CITY OF ALBUQUERQUE

Planning Department
Alan Varela, Director

RE: **Lot 5-A Block 6 Unit 18 SAD 228
6612 Kimmick Dr. NW
Grading and Drainage Plan
Engineers Stamp Date 4/5/2025 (D10D003M5B)**

ENGINEER'S SEAL 	LOT 5-A BLK 6 U 18 VC SUB. 6612 KIMMICK DRIVE DW	DRAWN BY DEM
	GRADING AND DRAINAGE PLAN	DATE 4-5-25
 P.O. BOX 53924 ALBUQUERQUE, NM 87199 (505) 321-8099	SHEET # C1	JOB #

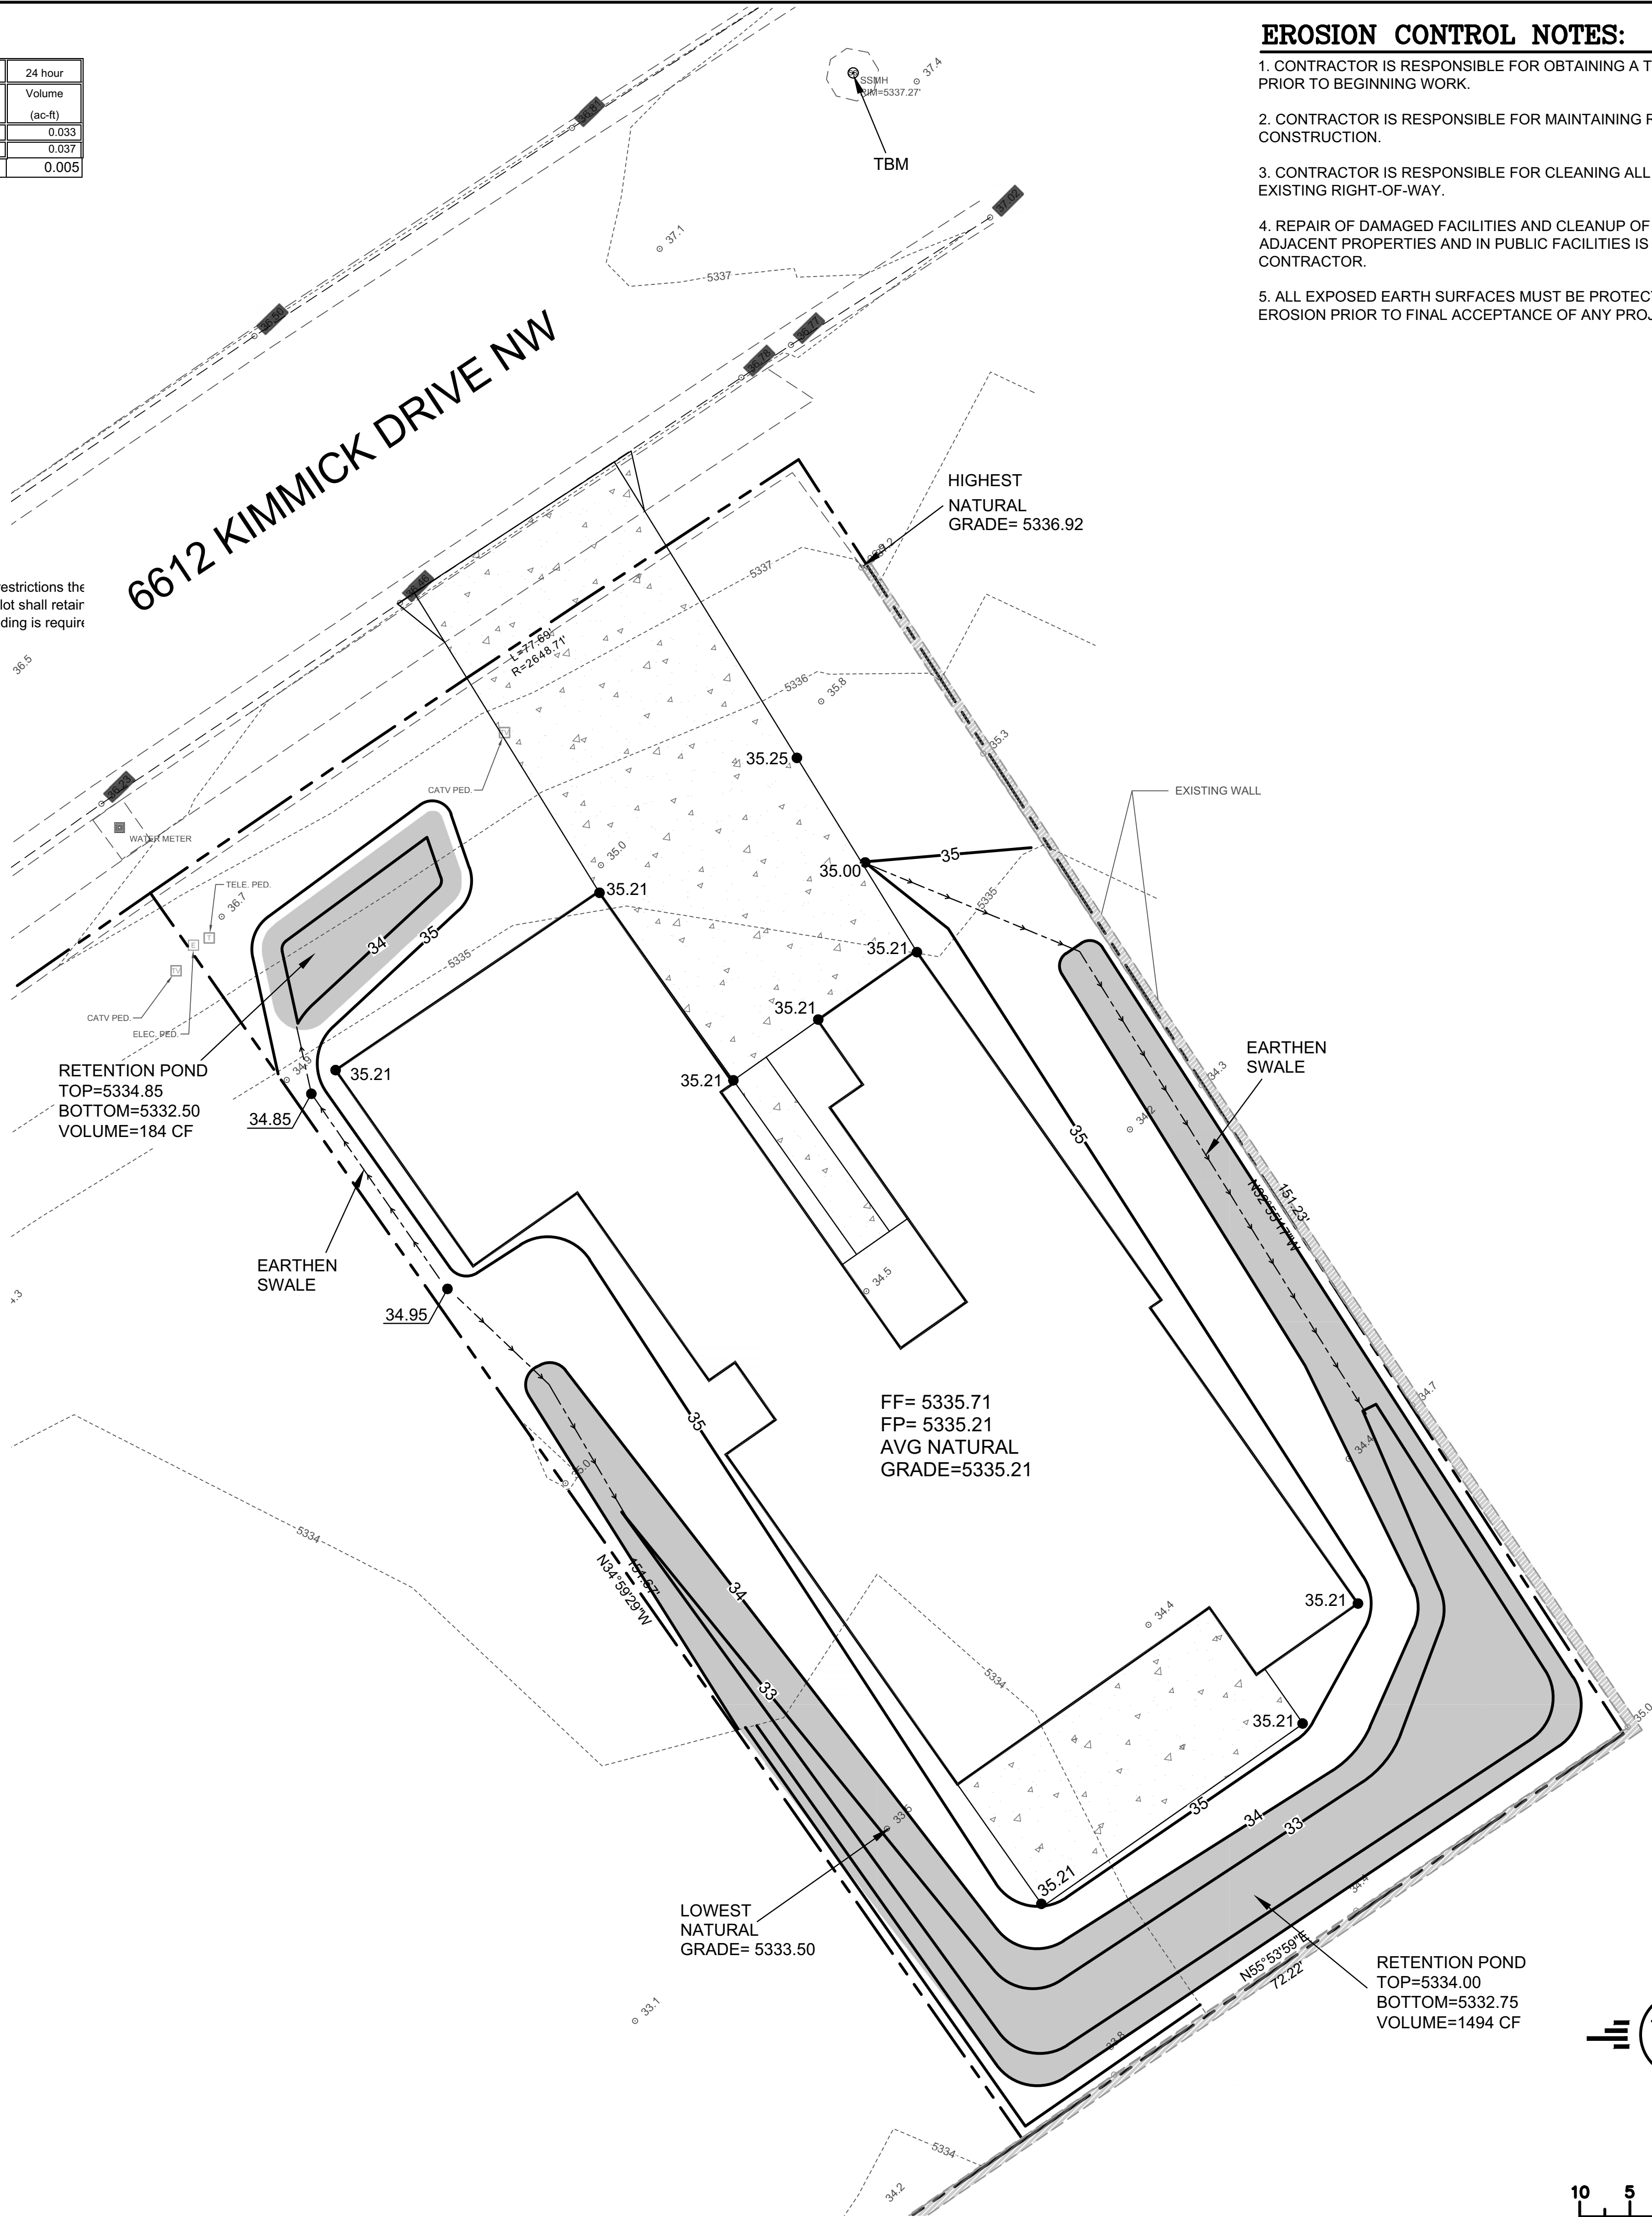
Prior to Building permit approval, a Pad Certification will be required, provided by the Engineer or a registered Land Surveyor.

Advise the owner contractor not to use dirt as a ramp to climb the curb, use lumber or crusher fines for this purpose.

Reiterate to the Owner/Contractor that a separate permit for a garden/retaining wall must be obtained with the approved G&D plan and Pad Certification. Also, if a swimming pool is to be placed the grading and drainage plan will change and will need to be resubmitted.

Prior to Certificate of Occupancy release, Engineer Certification per the DPM checklist is required.
